**STAFF REPORT
GREENFIELD ZONING BOARD OF APPEALS
THURSDAY, APRIL 25, 2024**

1. **Roll Call**
2. **Approval of the minutes from the September 28, 2023 meeting.**
3. **Zoning Special Exception petition for construction of an addition to an existing garage located at 11430 W. Cold Spring Rd., submitted by Eric Alar, d/b/a Enigma Engineering. (Tax Key No. 566-9956-009).**

4. **Zoning Special Exception petition for construction of a fence in the front yard, located at 3415 W. Wilbur Ave., submitted by Joshua Rivera-Cottes, owner. (Tax Key No. 553-0414-000)**

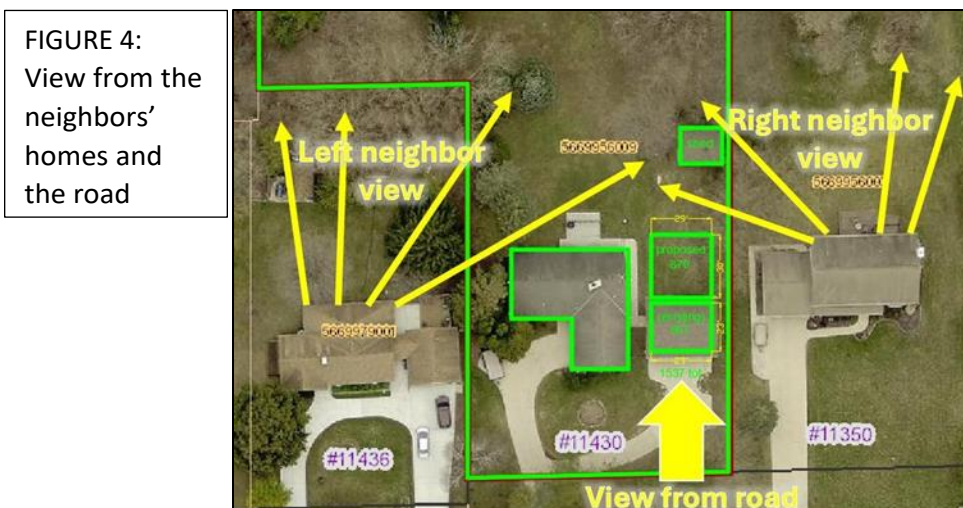
Instead, we are requesting an additional 537 ft² on the addition, bringing the total to 1537 ft², shown in following figure:

There are multiple reasons why our property presents **Exceptional Circumstances** to the zoning code section **21.09.0209** and requires this extra square footage:

*This exception request abides to **Preservation of Intent** on the Zoning Board Application by being consistent with the original purpose and intent of the regulations. This addition is not excessively large given the lot size – it is mathematically proportional to the lot size. We will rigidly abide by all other regulations including height restrictions.*

Staff recommends approval of the garage addition, as submitted.

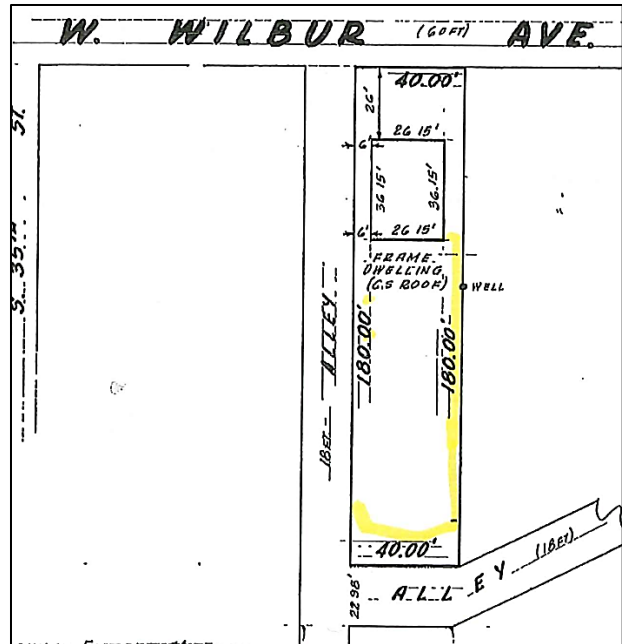
Section 21.04.0801(D) – Percentage of available rear yard occupied states that “no accessory building(s) or structures(s) may occupy more than forty (40) percent of the area of a available rear yard.” The rear yard at 11430 W. Cold Spring Road is approximately 30,000 sq. ft., the existing shed is 150 sq. ft. , and the total square footage of the proposed garage, which is not entirely located within the rear yard, is 1,537 sq. ft. Even with the entirety of the garage included in the rear yard calculation, only 5.6% ($150 + 1537 / 30,000$) is occupied by accessory structures.
